Appendix 1

2018 British Columbia Building Code

Review of Proposed Changes

Figure A-3.8.3.6.(11)
Doorway clearance

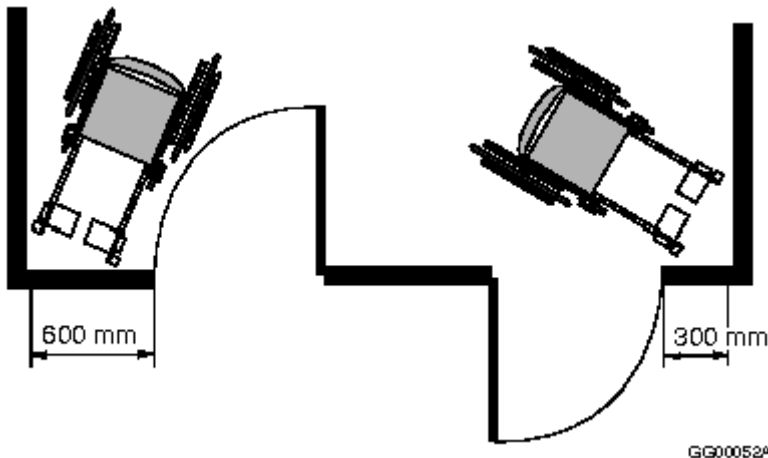
It is recommended to add requirements for clear space adjacent to sliding doors; the dimensional requirements recommended are similar to those of the CSA B651 standard.

A-3.8.3.6.(11) Clearance at Doorways. Sufficient clearance must be provided on the latch side of doors for a user to operate the door-opening mechanism and open the door without interference from the wheelchair. This is particularly important for a door swinging towards the approach side. See Figure A-3.8.3.6.(11).
